From: Dr. Max Lee
To: Subramaniam, Pawan
Cc: Linero, Alvaro
Subject: 307-15-02 307-15-03 FW: 0530021-053-AC-PSD-91M, CEMEX Construction Materials Florida, LLC, Brooksville South Cement Plant, Draft Permit
Date: Monday, April 06, 2015 4:44:39 PM
Attachments: image001.png
0530021-053-AC - Written Notice_signed.pdf
0530021-053-AC - Public Notice.docx

0530021-053-AC

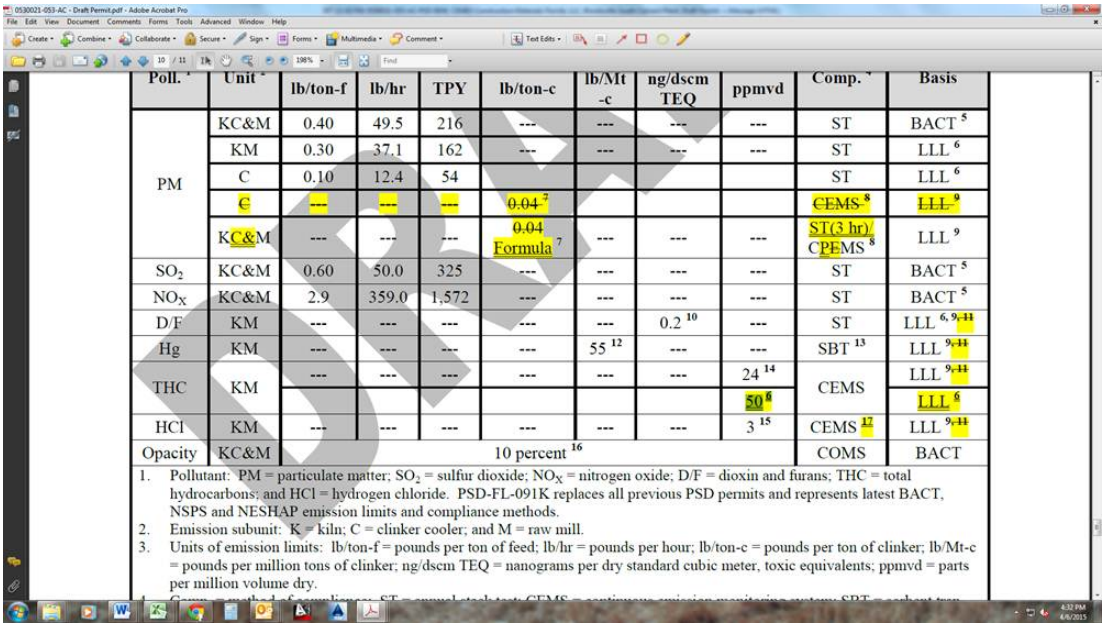
The primary issue of concern is on page 10 of 11 where the revisions proposed for AC permit 043-AC state NESHAP THC limit must be compiled with (50 ppmvd by CEMS until 9/9/15). Screenshot below.

Similar to the Miami Cemex kiln which is not subject to this NESHAP limit, that limit applies only to new (greenfield kilns) built after March 24, 1998.

So please confirm for me by email response that the 50 ppmvd limit and related monitoring prior to 9/9/15 is not required and revise the proposed 043-AC permit revisions.

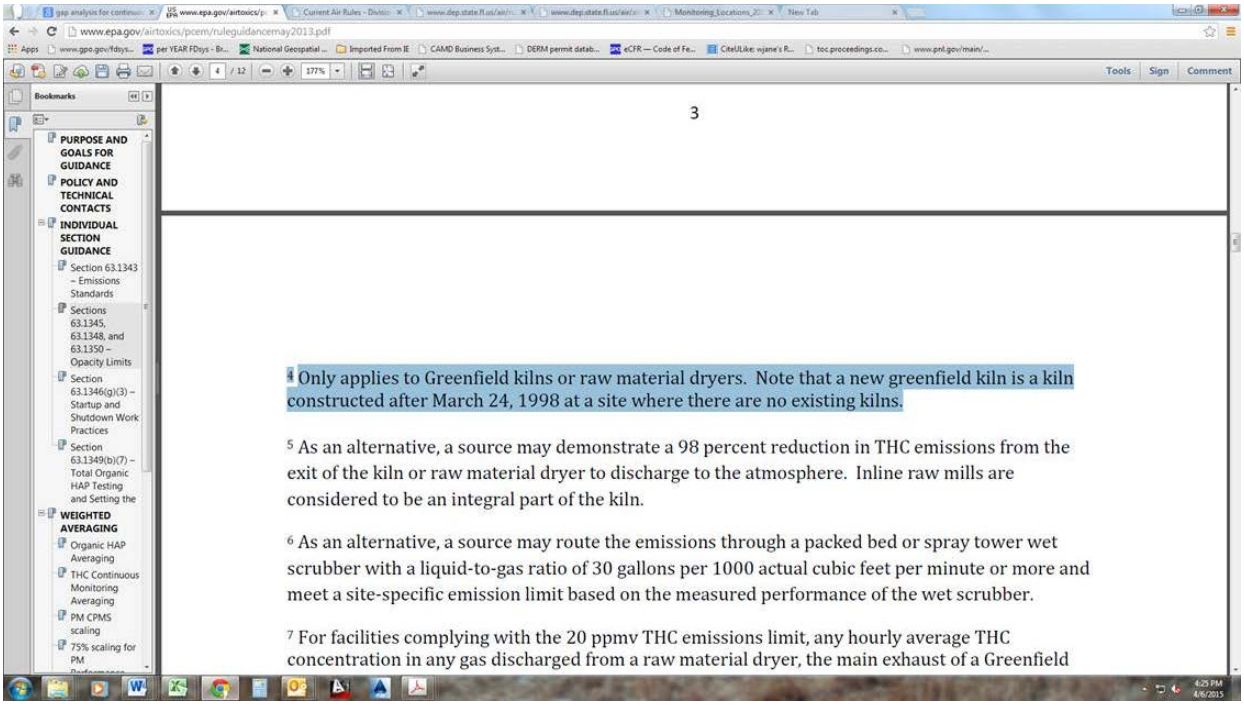
As well, I have screen shot the document with a highlight below.
